Horn Lake

Replacement Highland Road Culvert

High Water Level Since Installation

Data Summary and Conclusions

Highland Road Culvert
Elevation Schematic
May - 02 - 2021

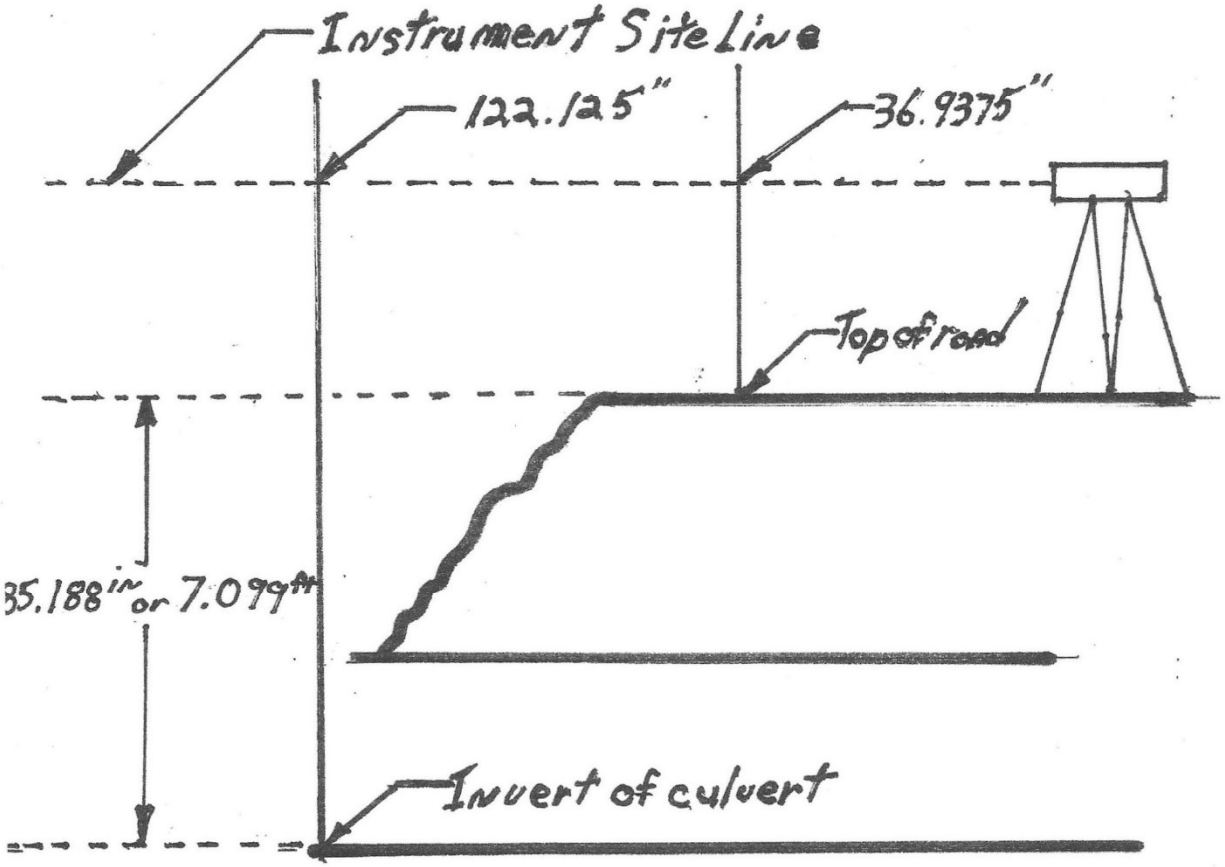
Horn Lake Highland Rd. Culvert Installation Scenarios

As you can clearly see from the picture below, we could not verify the elevations from the Bench Mark at the solid iron bar (SIB) as it not set in solid ground and therefore unreliable. We can only go by the centreline or top of the road as the starting point for the elevations.
